Subject: 2015 SMARA Inspection Report for the Stevens Creek Quarry

County Planning Office File 1253-15PAM

State Mine ID #91-43-0007

2015 Annual SMARA Inspection

Photo 3 (Slump Repair, Parcel A)

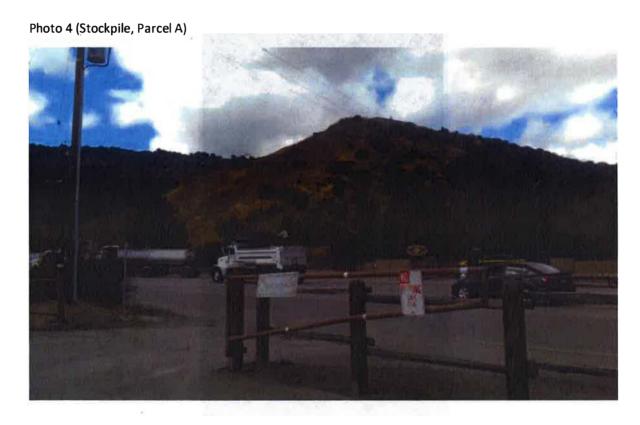
Slump Repair: An area located behind the recycling operation on Parcel A had a slump repair (2012) and is stable, no changes observed. (Photo 3)

Photo 7 (Older fill slop, Parcel B)

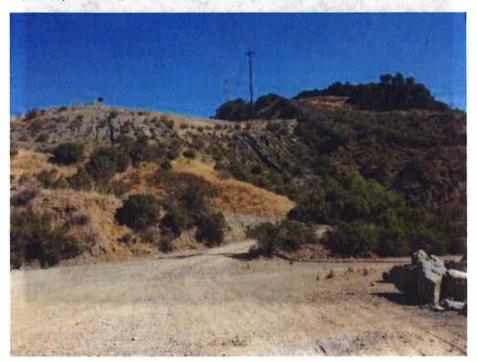
Stormwater BMPs: County observed ongoing erosion gullies located on fill slopes (Parcel B) above haul road. County requires operator to implement soil stabilization measures and install adequate BMPs no later than November 1, 2015. Erosion control and BMP measures, including hydroseeding for winter, should be implemented at all locations where active grading or disturbed soil (new crusher, fill slope near creek, etc.). County shall conduct a final inspection of the completed work. (Photos 7, 8, and 9)

Photo 10 (Rock Crusher Relocated, Parcel B)

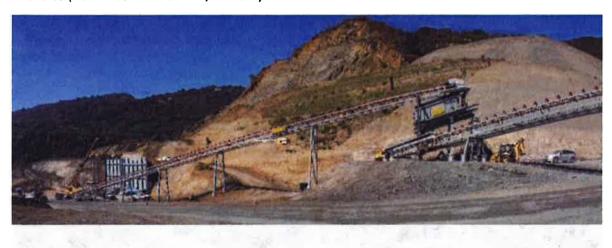
Crusher and Retaining Wall: Mining is conducted in Parcel B in a north-northwest trending quarry where Franciscan greenstone bedrock is extracted. Equipment for crushing and sorting rock materials is located on Parcel B. Inspectors observed crusher equipment was in process of being relocated during the inspection to the southeast portion of Parcel B. Building permits are required for the foundation and the retaining wall. A Stop Work Order was issued on September 2, 2015 to the Operator and instructed to apply for the appropriate building permits from the County. The Operator stated they will apply for building permits on October 16, 2015. (Photo 10)

Photo 12 (Quarry pit, looking down, Parcel B)

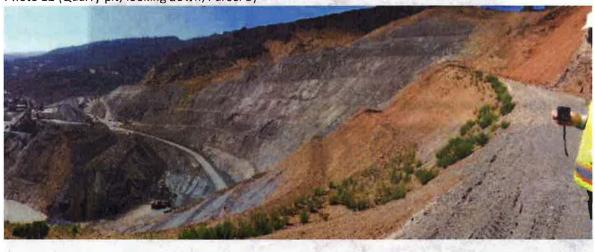
Quarry Pit: Looking west at high wall cuts. Localized slumping has occurred between benches that will be buried by fill during reclamation. Looking down on northern slope of pit, localized cracking and erosion rills have formed in the slope. Operator (verbal communication w/ R. Voss October 6. 2015) agreed to obtain a geological evaluation by Sandy Figures, CEG, to assess potential instabilities or movement that may jeopardize reclamation. This report shall be completed and submitted to County on or before Dec. 1, 2015. Also observed upper access road (north) is located within a few feet of property line and Reclamation Plan boundary. County recommends operator demarcate the property line along in the area of the access road prior to next SMARA inspection. (Photos 11, 12, 13 and 14)
